145-18-CA

314 N BOUNDARY
STREET

Nature of Project:
Remove and replace 10 trees;
install 46" wood fence and masonry
retaining wall in front yard;
install 8' fence in back yard

APPLICATION FOR A CERTIFICATE OF APPROPRIATENESS – STAFF REPORT

PLOT PLAN C

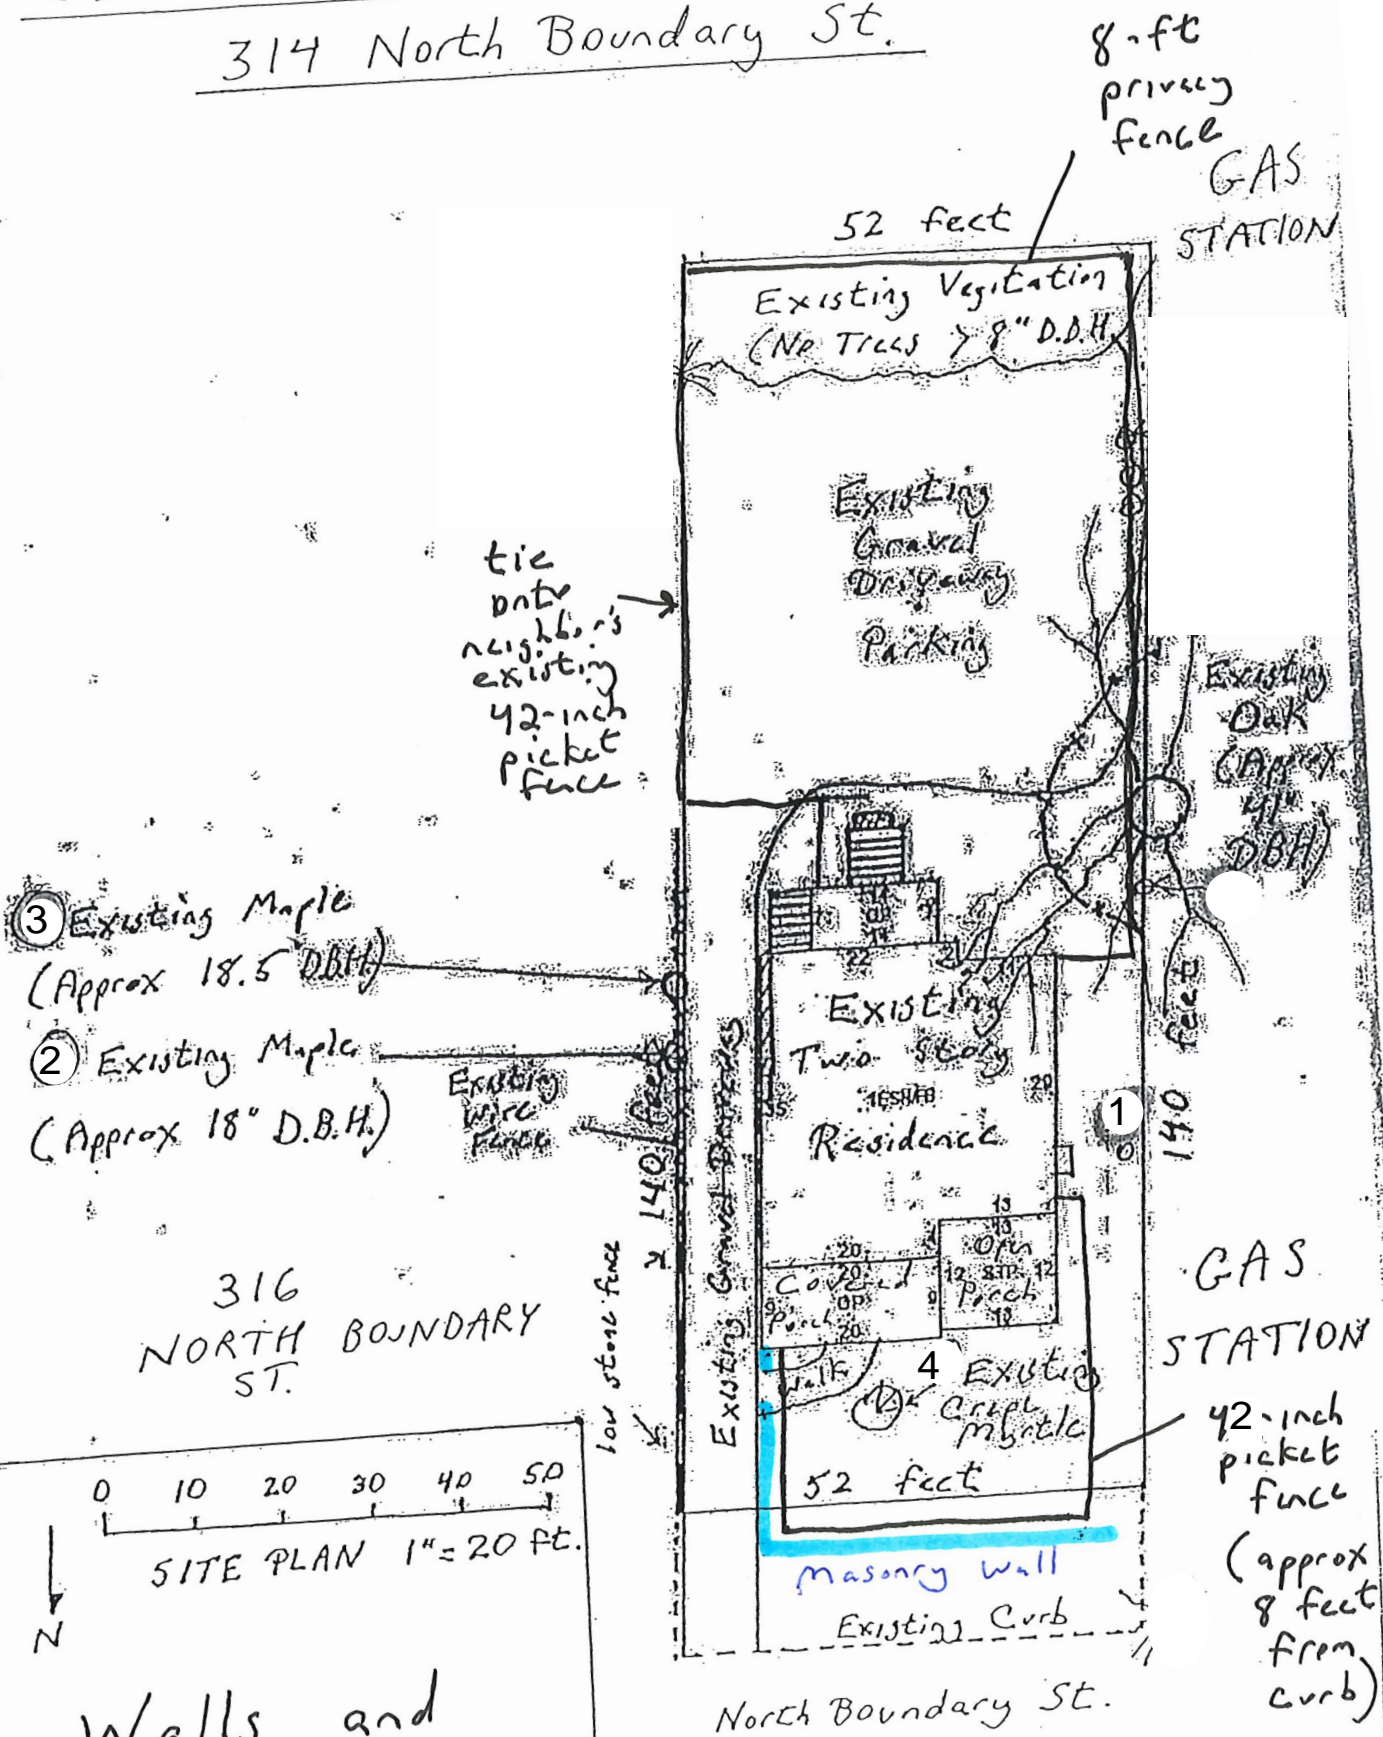
4. Please provide a site plan of the front yard, showing the side walk, curb, street, and proposed fence and wall.
5. Please submit a drawing or photograph of the proposed fence design and a section drawing of the proposed retaining wall. Will the retaining wall be back filled or set into the topography of the site? Please also provide a sample of the proposed materials for the wall.

6. Please include a topographic drawing of the site. This can be obtained from iMaps.

The proposed location of our new front yard fence is shown on the attached "**Plot Plan C.**" The fence setback is essentially the same as the setbacks of the existing white picket fences at 316 North Boundary Street and 318 North Boundary Street. Likewise, the fence color (white/alabaster), material (wood), and overall fence appearance are similar to these neighbors' existing fences. The height of the fence will, due to topography, vary somewhat but won't exceed 42 inches in height.

See **Plot Plan C** for proposed location of masonry fence.

See **Plot Plan C** for proposed location of the privacy fence.

Photo 8

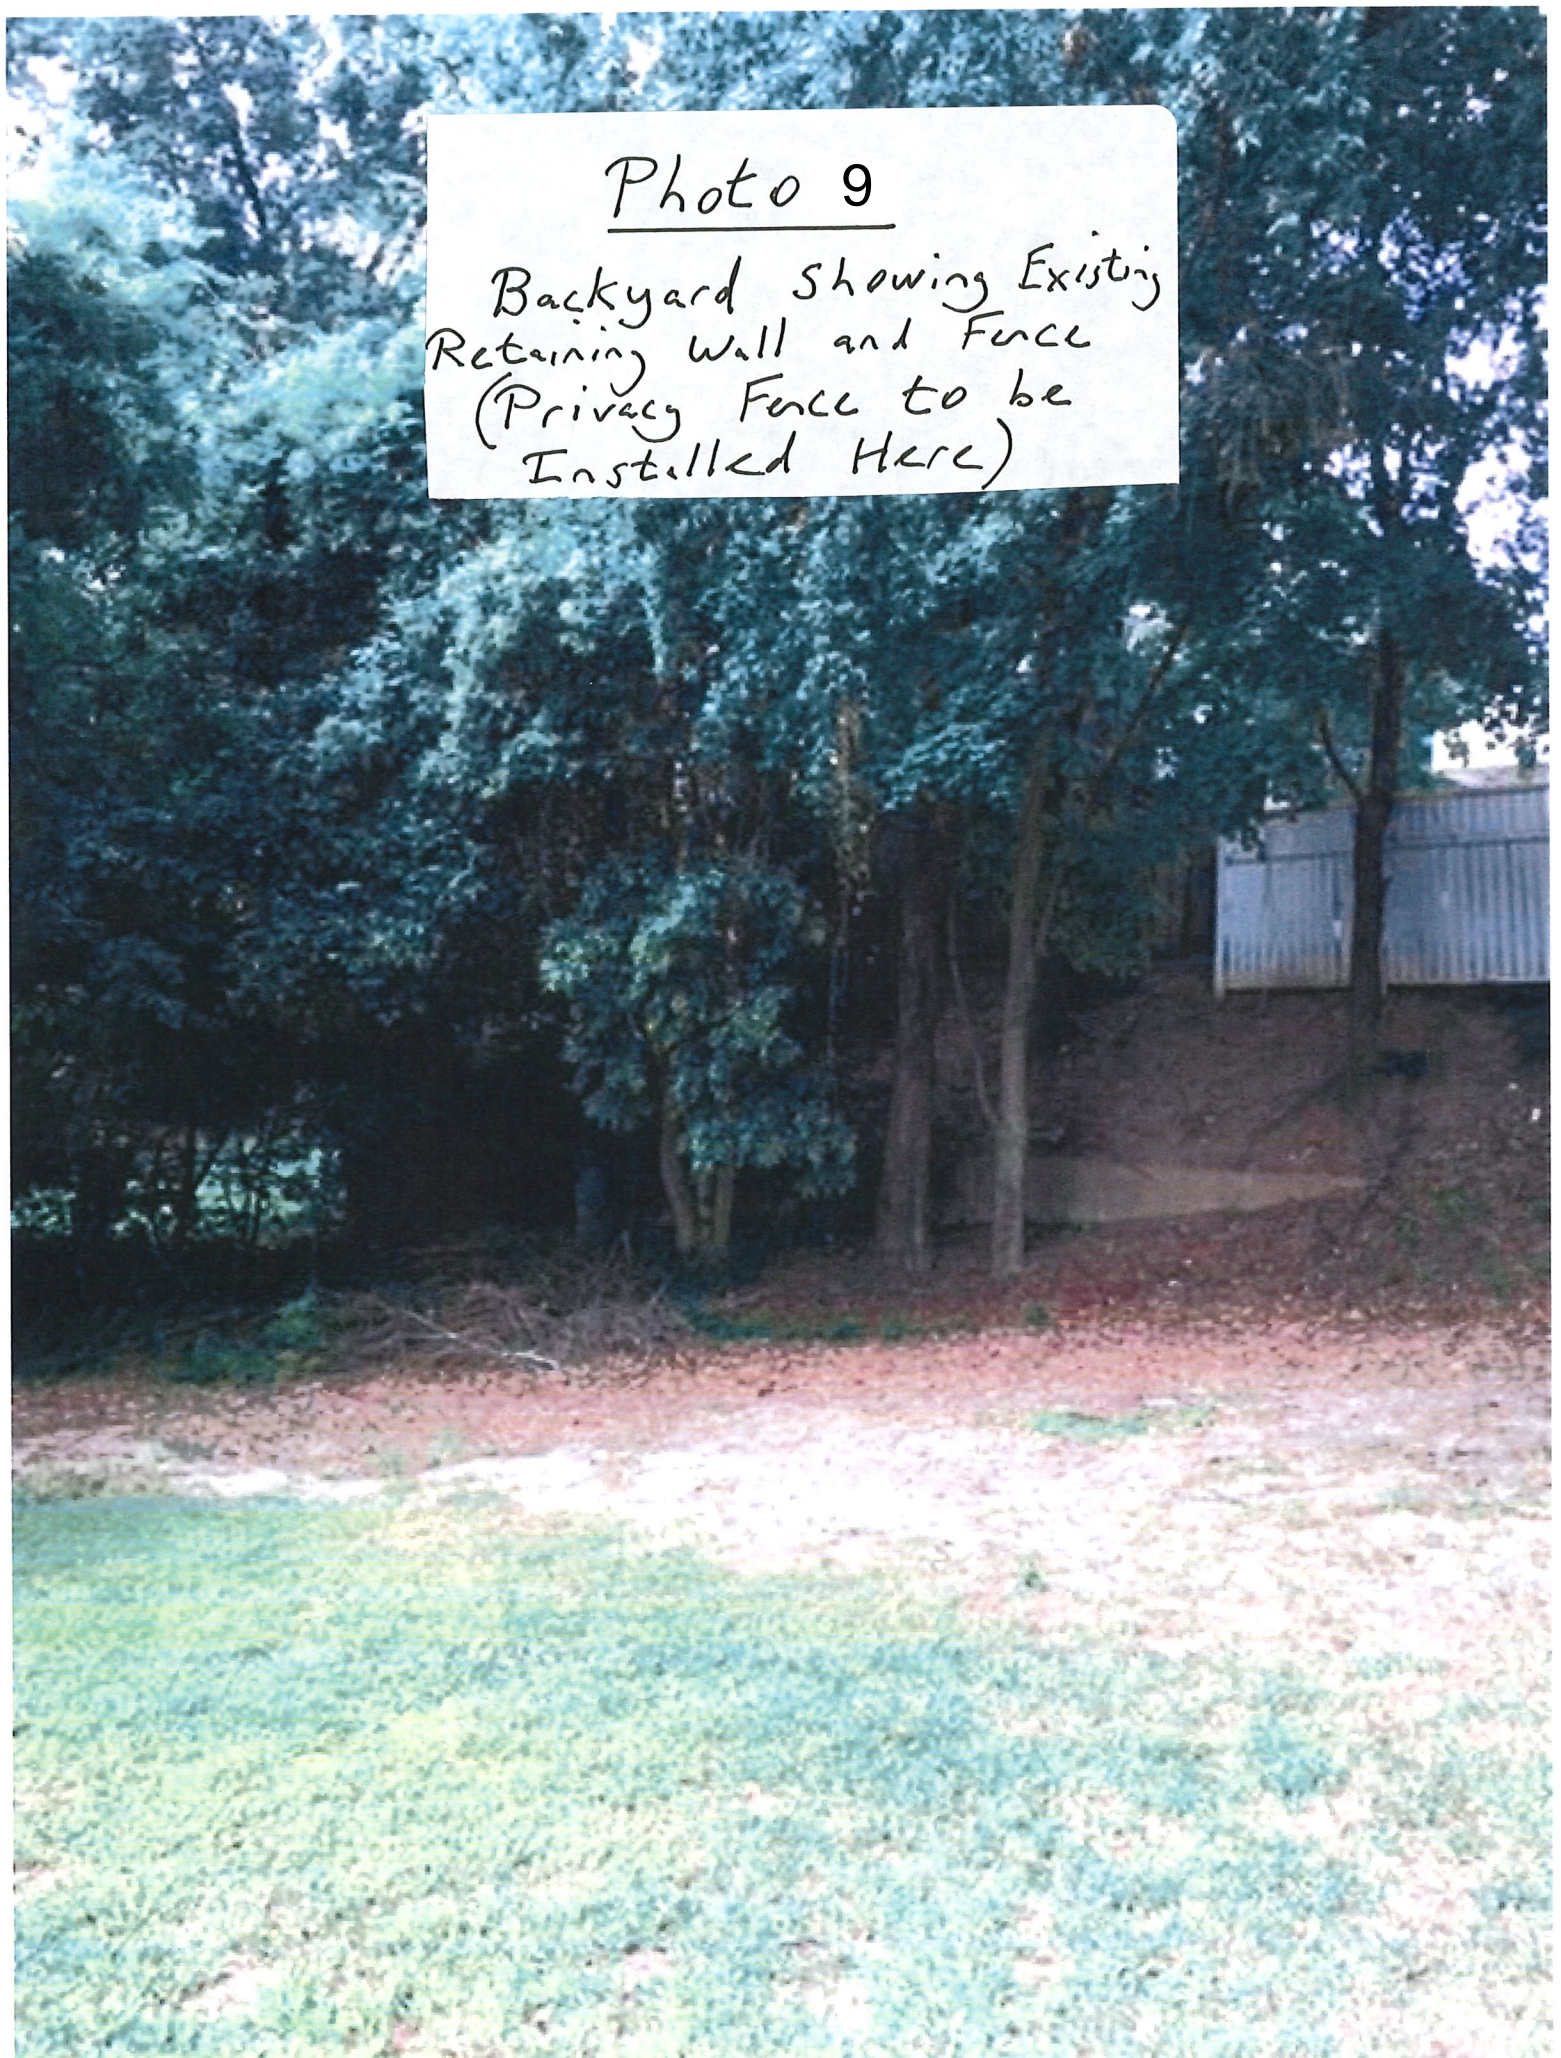
- 2* The applicant proposes the construction of an 18” tall masonry retaining wall **along the west edge of the driveway. The wall is proposed to match the existing low stone wall located on the east side of the driveway.** Drawings of the proposed wall either in elevation or section were not provided.

- 3* The masonry wall will replace currently existing railroad ties.
- 4* The application also proposes the installation of an 8’ tall wood privacy fence along the west and south property lines in the rear yard.

Photo 9

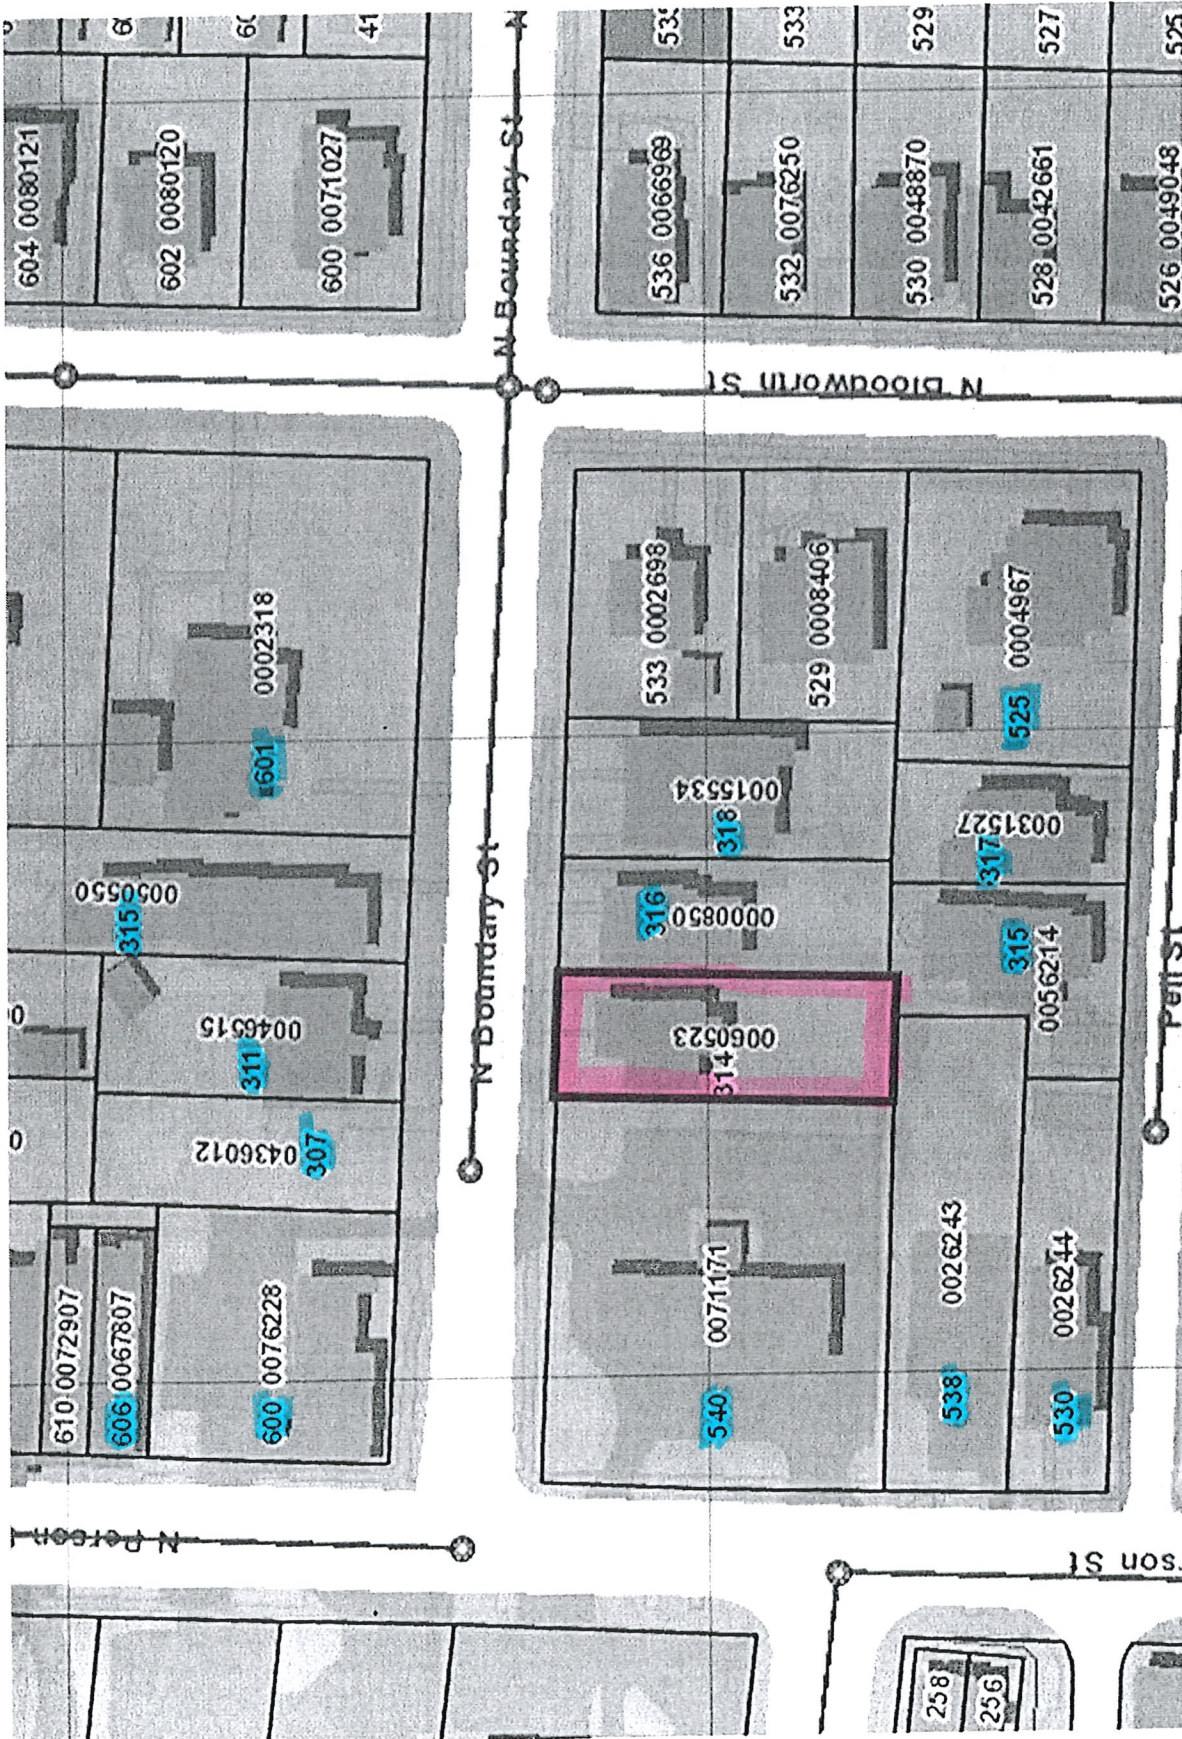
- 5* **The fence height will be reduced to 6’ where it abuts the house and for approximately 15’ from its starting points on the east and west property lines to reduce the height visible from the street.**

- 6* The proposed tall privacy fence locations abut properties that are not included in the Oakwood Historic District. One property is a commercial gas station, the other is a vacant lot.

Staff suggests that the Committee discuss the proposed 8’ height of the fence. Pending the results of that discussion, staff suggests the Committee approve the application with the following conditions:
